Re: Response to Engineering Peer Review - Traffic  
Brush Hill Homes Residential Development – 34 Brush Hill Road  
Sherborn, Massachusetts

Vanasse & Associates, Inc. (VAI) is providing responses to the comments that were raised in the August 27, 2024 *Engineering Peer Review – Traffic* letter prepared by Tetra Tech (TT) concerning their review of the August 5, 2024 *Transportation Impact Assessment* (the “August 2024 TIA”) that was prepared by VAI in support of the proposed Brush Hill Homes residential development to be located at 34 Brush Hill Road in Sherborn, Massachusetts (hereafter referred to as the “Project”). Listed below are the comments that were identified by TT in the subject letter followed by our response on behalf of the Project proponent.

Figure 1a

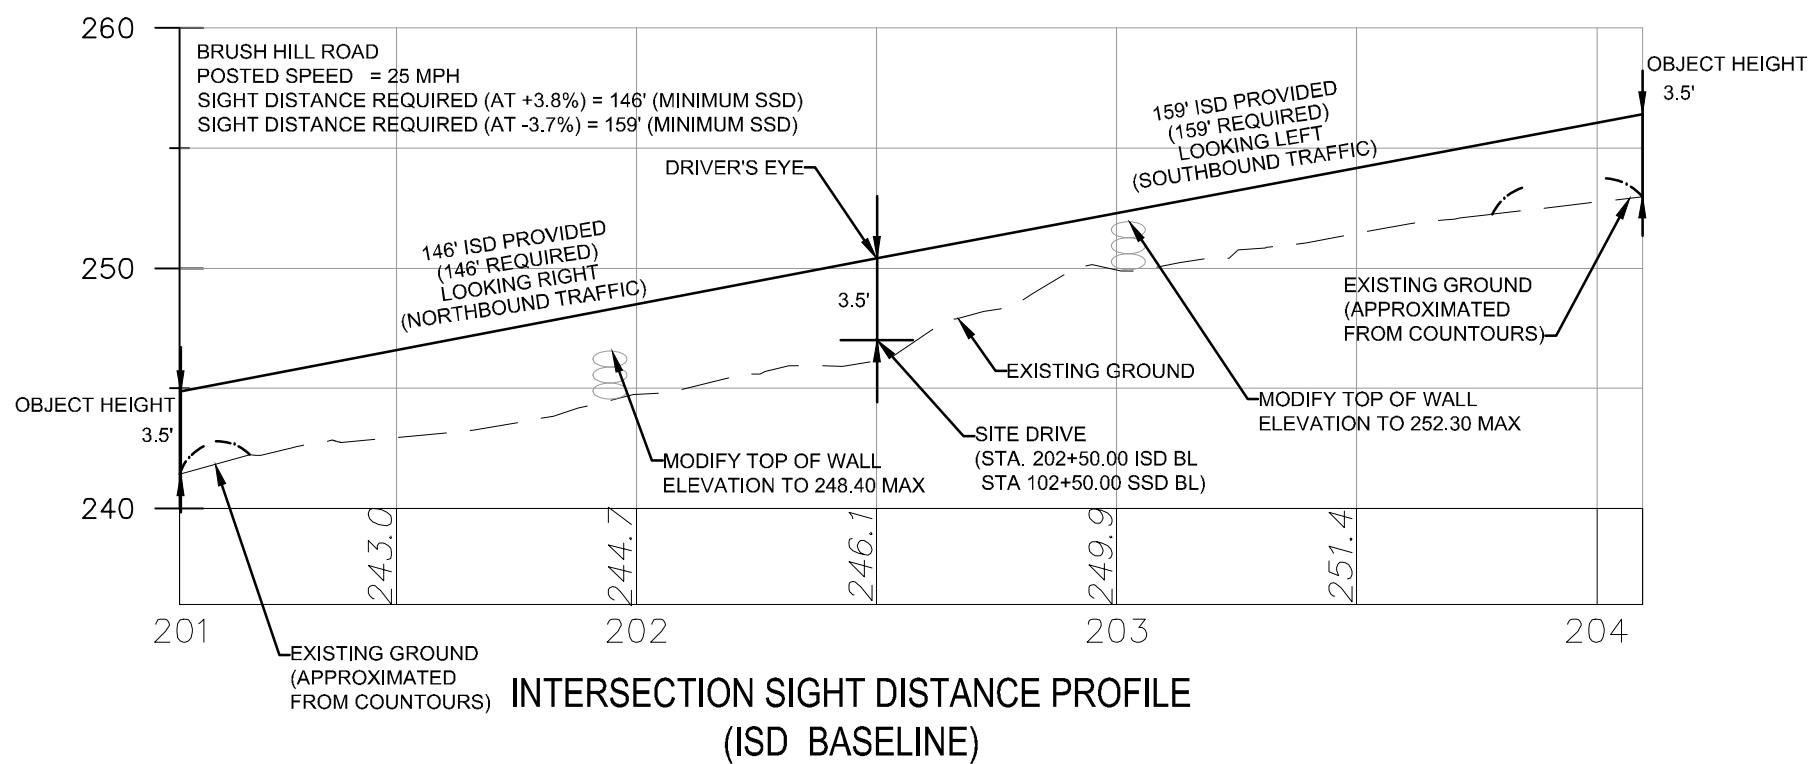
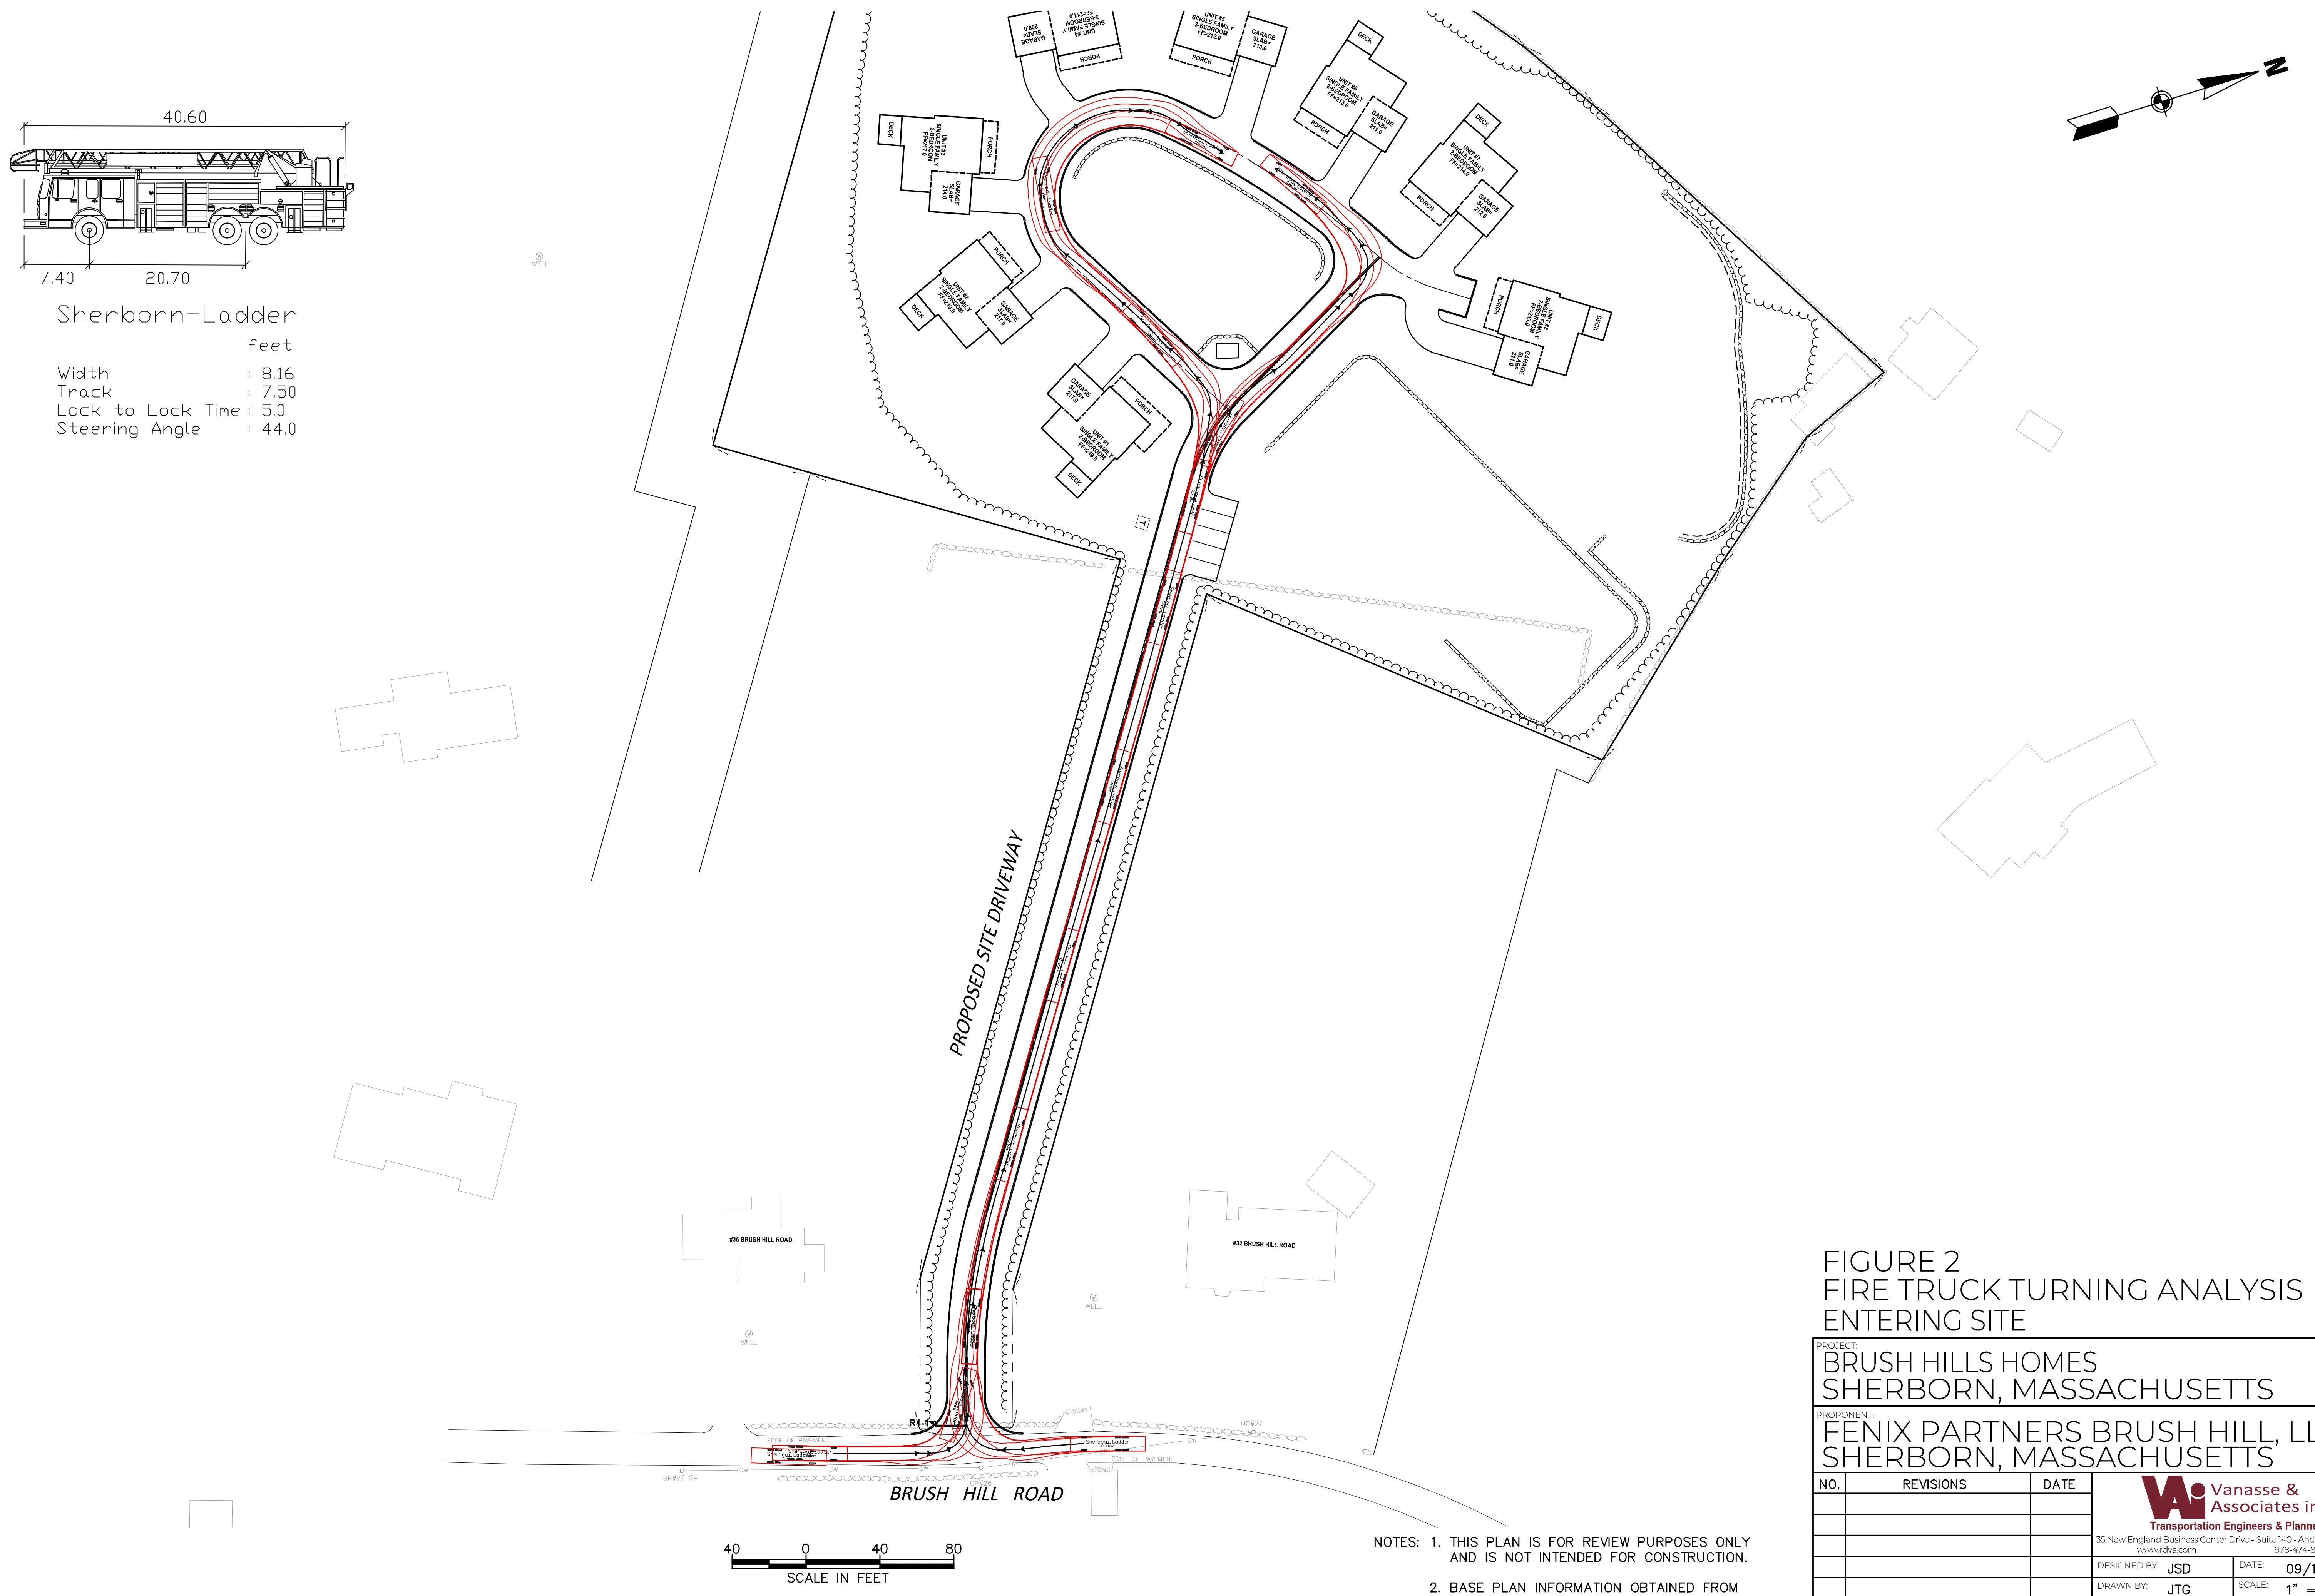
*Comment 5:* *Tetra Tech recommends that the sight distance plans and profiles for the site access roadway be added to the site plans to confirm that adequate sight distance will be provided at this location. Any existing vegetation or guardrail required to be removed to provide adequate sight lines should be identified for the Town’s review. Additionally, the Applicant should ensure that all proposed landscaping and signage internal to the site (where vehicle conflicts may occur) will not impede sight lines.*

**Response:** As requested, sight distance plans have been prepared for the Project site driveway intersection with Brush Hill Road that depict the sight lines in both plan and profile views and are attached. The plan view drawings illustrate the areas where the selective trimming/removal of trees and vegetation should occur. The

plan view drawings illustrate that the stopping sight distance along Brush Hill Road meets the recommended criteria and indicates the extent to which the existing stone walls on either side of the driveway need to be modified to provide the recommended minimum sight lines for a motorist exiting the driveway and looking to the left and right. The selective trimming/removal of trees and vegetation and the identified stone wall modifications will be completed in conjunction with the Project subject to receipt of all necessary rights, permits and approvals. We note that it is not necessary to clear all vegetation within the sight triangle areas; however, large trees that are proximate to the driveway should be removed.

# FIGURE 2

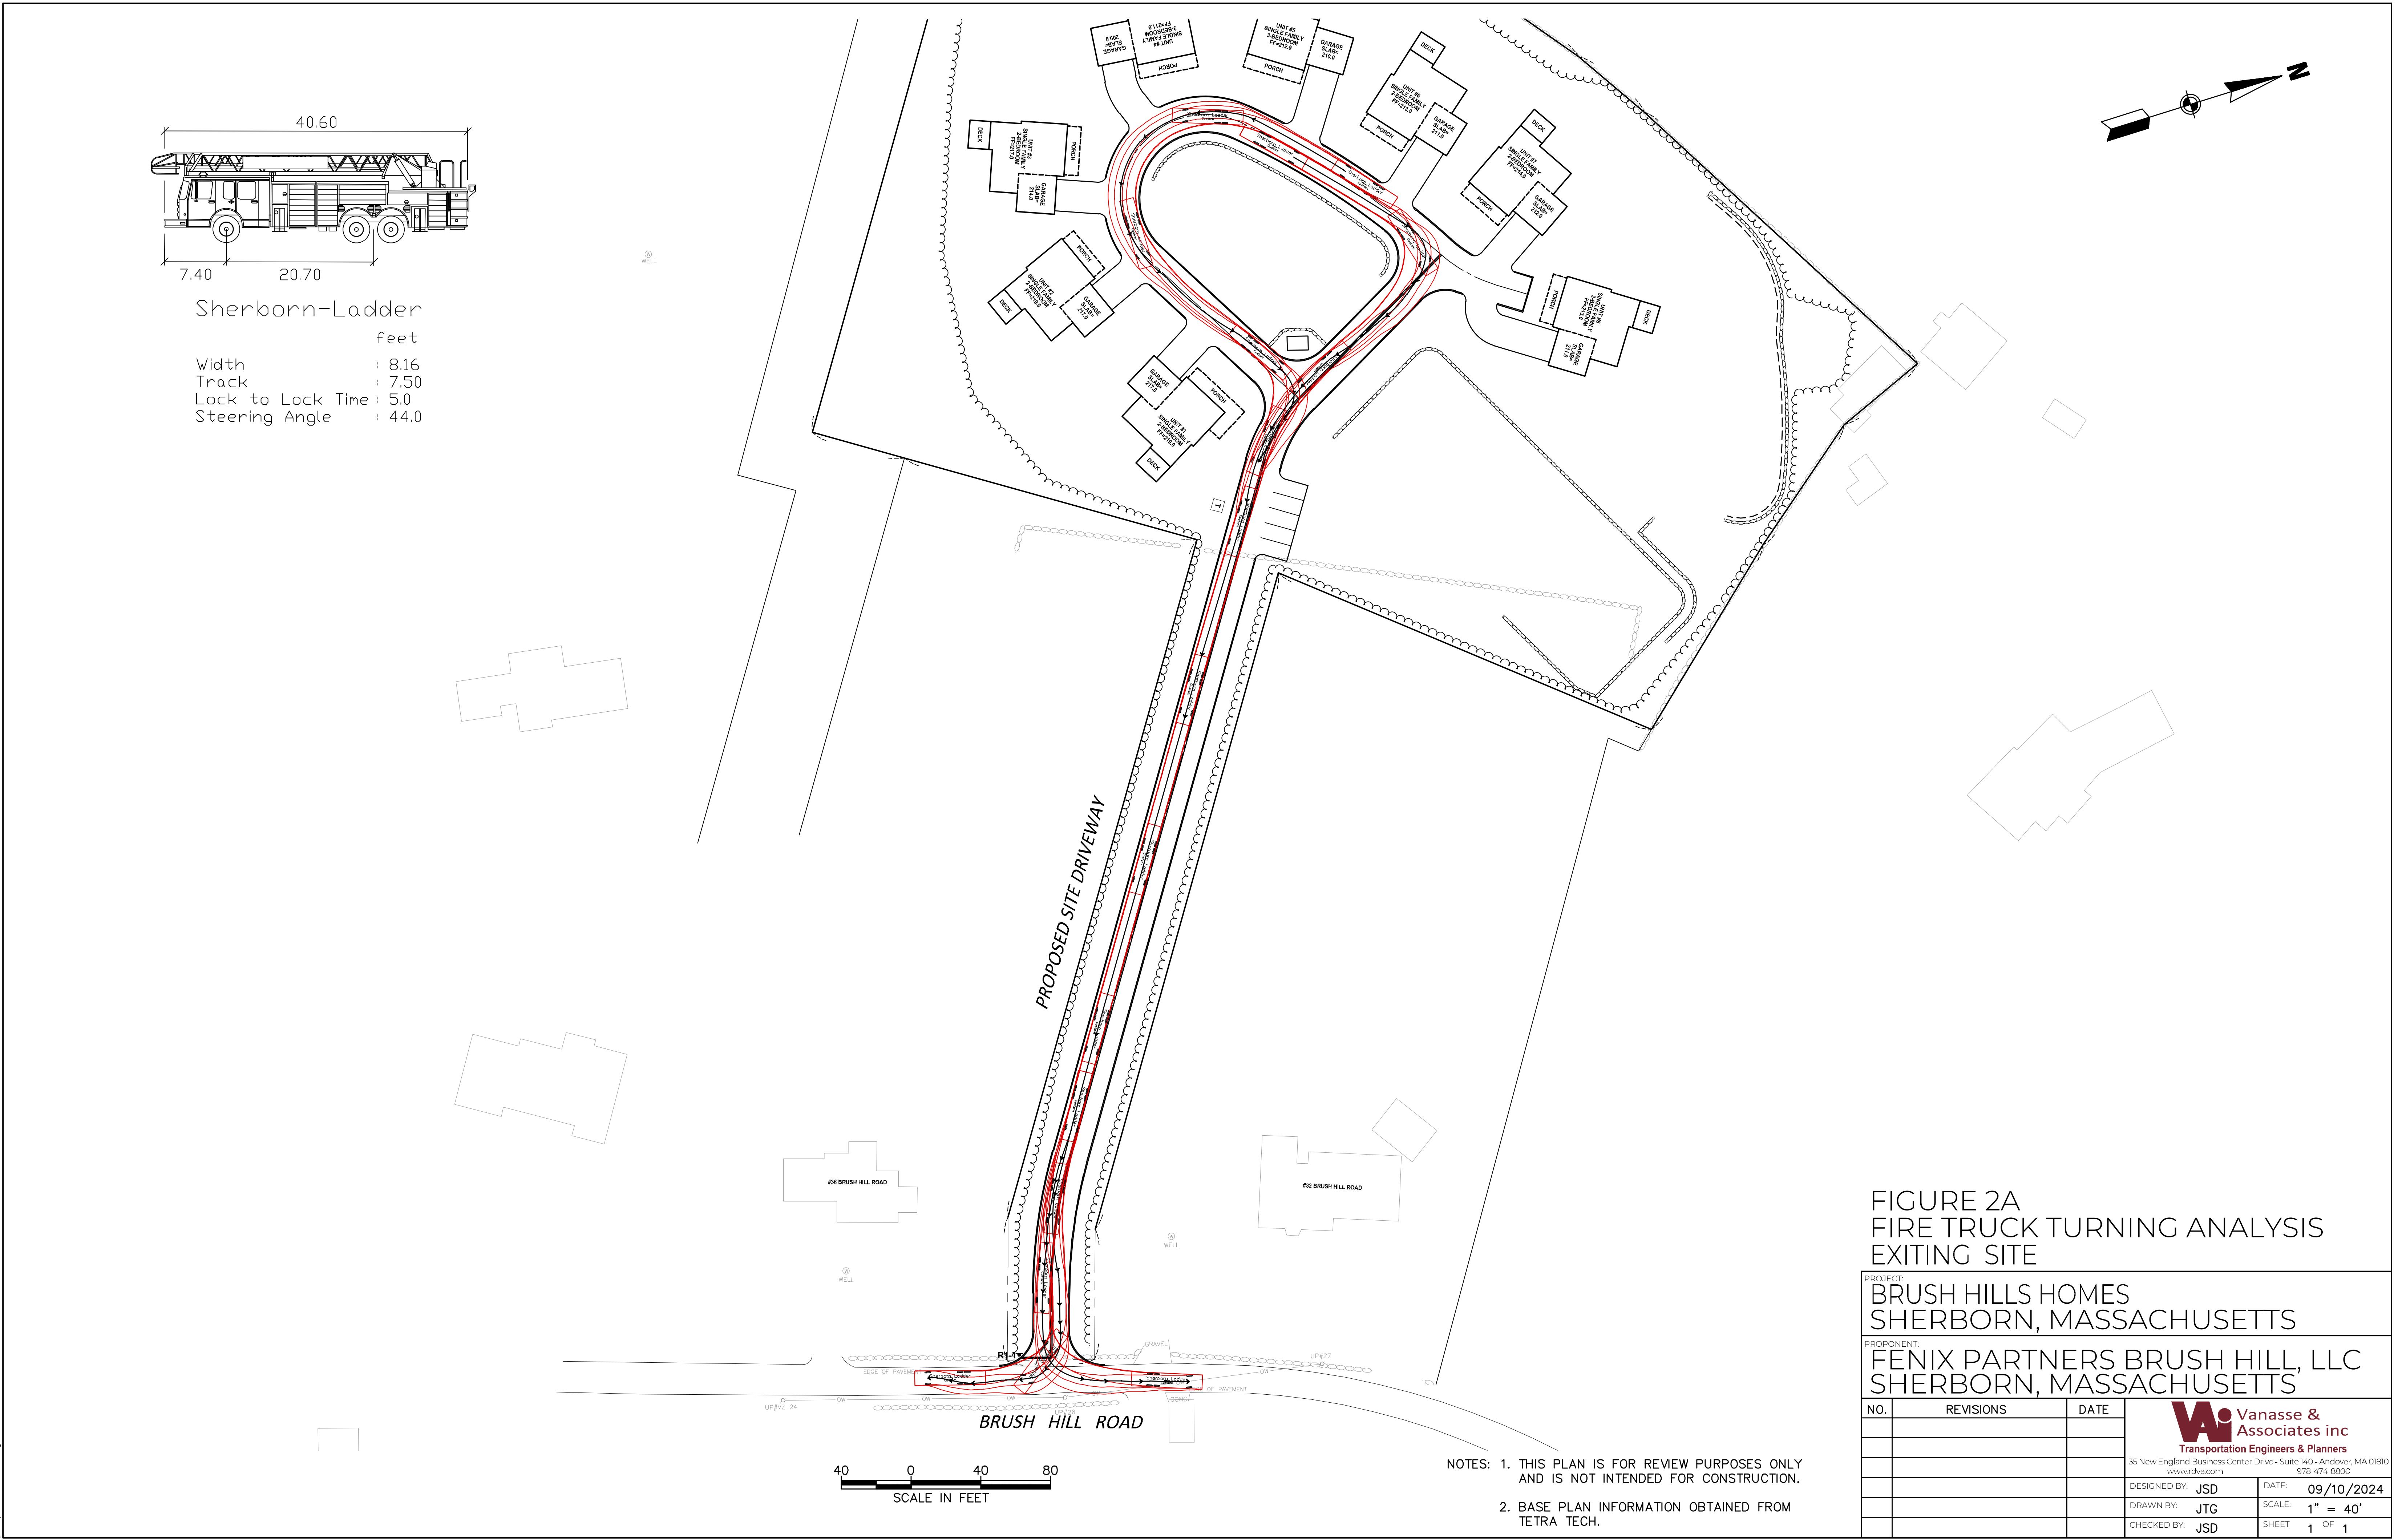
**Comment 7:** *Tetra Tech recommends that the Applicant conduct a turning analysis of the largest emergency, trash and delivery vehicles anticipated to use the site to confirm that the site access roadway design can accommodate the Project. Tetra Tech recommends that the Applicant review the site access and circulation with the Fire Department to confirm that the Town's largest emergency apparatus can adequately access the site.*

**Response:** A vehicle turning analysis has been completed for the Sherbon Ladder Truck and is attached. The turning analysis illustrates that the subject vehicle is able to enter and exit the Project site from Brush Hill Road and circulate within the development in an unimpeded manner. The trash/delivery vehicle is smaller in size than the Sherbon Ladder Truck (30 feet vs. 41 feet) and will maneuver in a comparable manner. As such, a separate turning analysis was not provided for the trash/delivery vehicle.

SHEET TITLE: **SNOW DISPOSAL EXHIBIT PLAN**

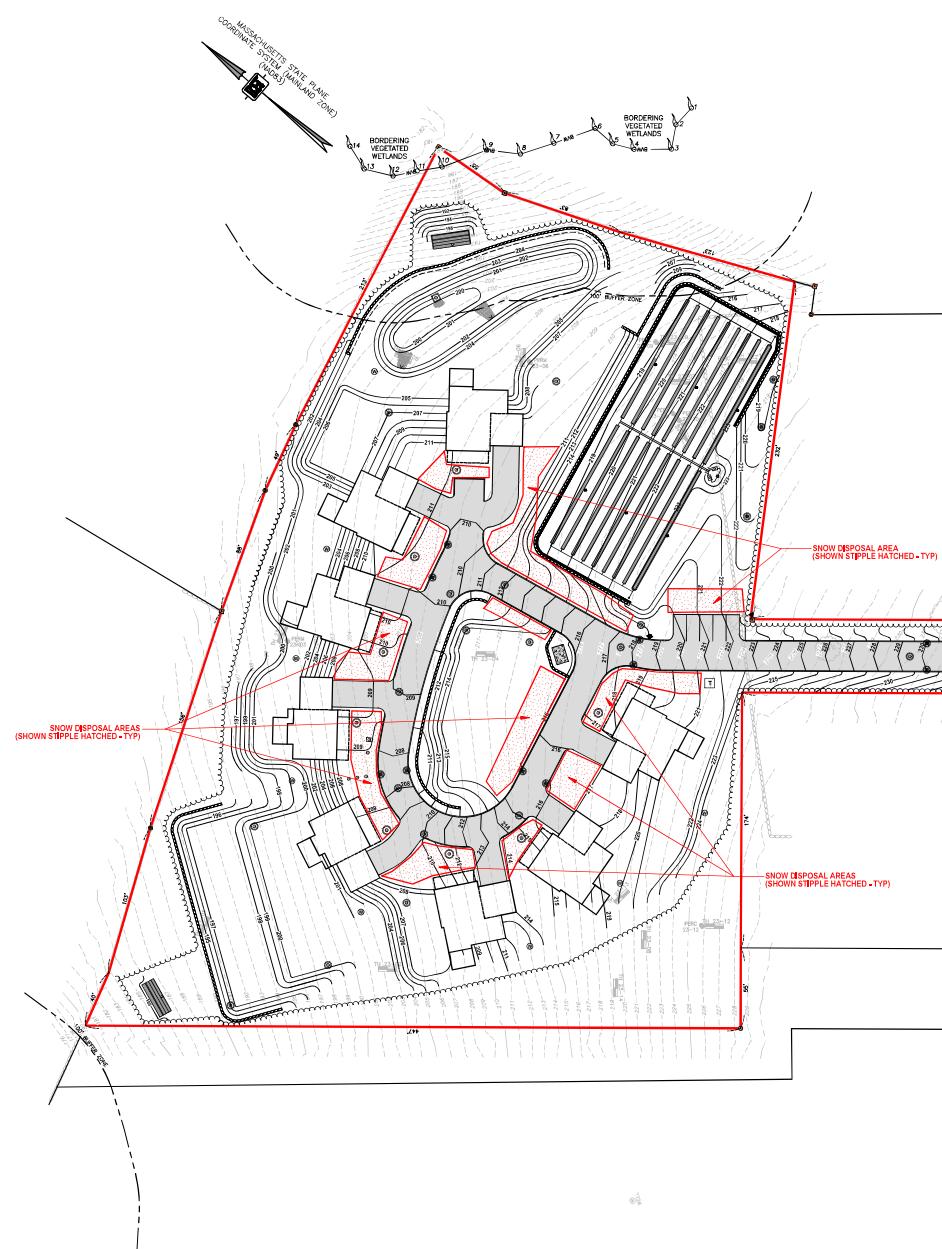
*Comment 11:* *Tetra Tech recommends that the Applicant label the snow storage areas and ensure that adequate snow storage will be available on-site without impeding parking, site access, sight distance and circulation.*

**Response:** A snow storage plan is attached.
